28 August 2024

K200826-4

**GEOTECHNICAL RESPONSE TO COUNCIL SECTION 92 REQUEST FOR FURTHER
INFORMATION - ADDITIONAL COMMENTS - BUN60406128 (LUC60406129, SUB60406160),
WAT60412104 & DIS60412103
PROPOSED SUBDIVISION - 2127 KAIPARA COAST HIGHWAY, MAKARAU**

Project		K200826-3 - Kaipara Coast Highway	
	Group		Critical Case Wastewater Dispersal Area	Scenario
	Drawn By		TR	Company
	Date		27/02/2024, 12:11:36 pm	File Name
			Run 5 - Seismic - Circular	KGA Geotechnical Group Limited
			WW Slide.sldm

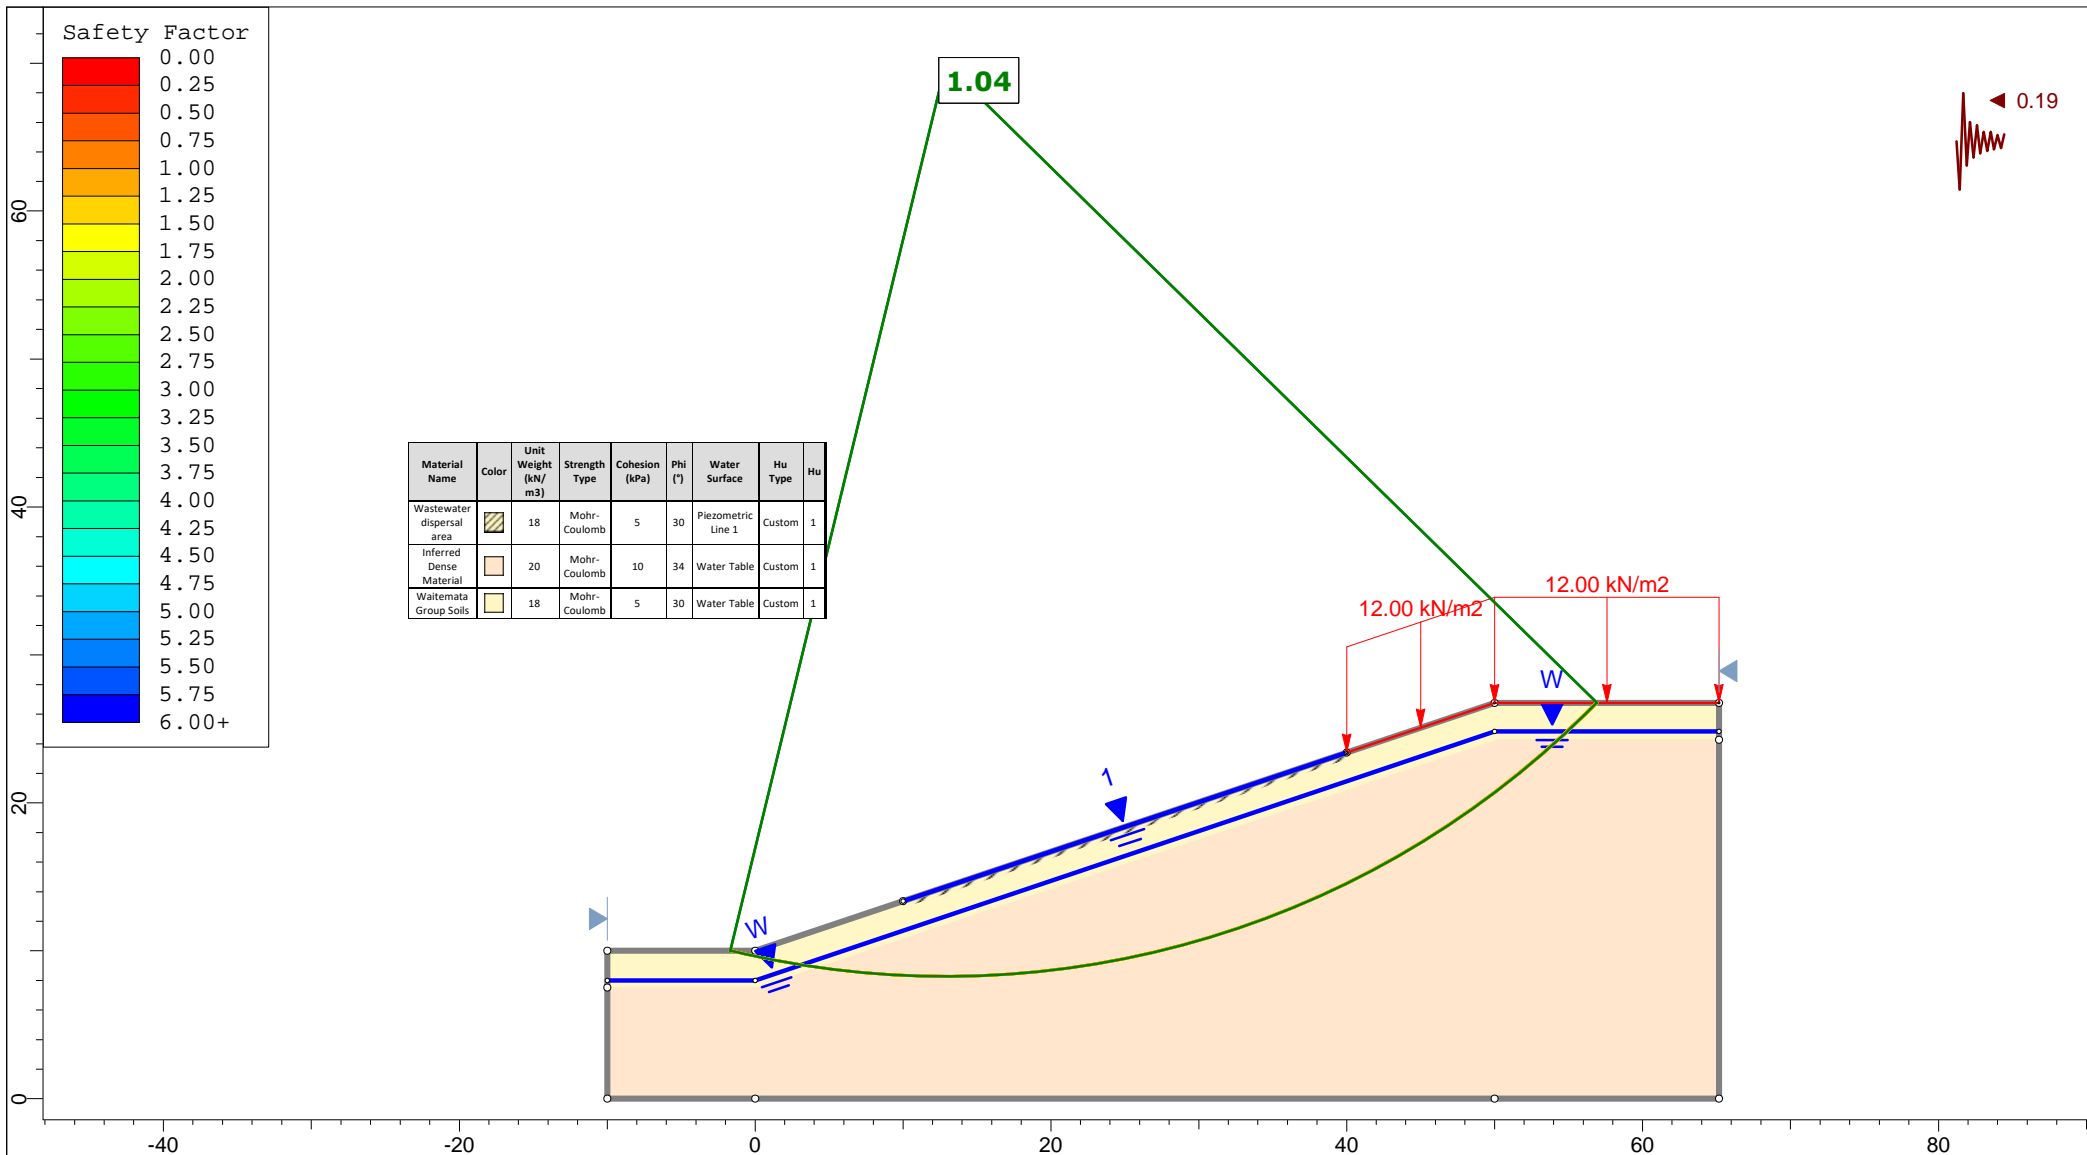
Council’s Specialist notes the wastewater disposal area is in the close vicinity of the proposed building platforms by the provided analysis are neither lot specific not considering surcharge load for a platform. Please clarify or revise analysis accordingly.

To reiterate the previous response, due to the scale of our global assessment, applying the potential dispersal areas to the entirety of the slope is not feasible due to the limited depth of affected soils comparative to the size/length of each model. Instead, a ‘worse case’ saturated upper slope scenario was assessed with a maximum gradient (1 vertical of 3 horizontal) to be encountered on the site.

The model has been updated to include a 12kPa surcharge upslope of the dispersal field to represent a potential building platform. A summary of the Factor of Safety results from the analyses is presented in Table 2 below. For detailed results, the slope stability calculation has been attached to the rear of this letter.

The results of the stability analyses indicate that the sloping ground with saturated upper 1.0m have acceptable Factor of Safety results for all conditions in accordance with “Auckland Code of Practice for Land Development and Subdivision, Chapter 2: Earthworks and Geotechnical”, July 2022. As such, as a preliminary assessment we considered the proposed wastewater dispersal areas feasible. This model is a proof-of-concept and is carried out to show dispersal is feasible on the sloping ground.
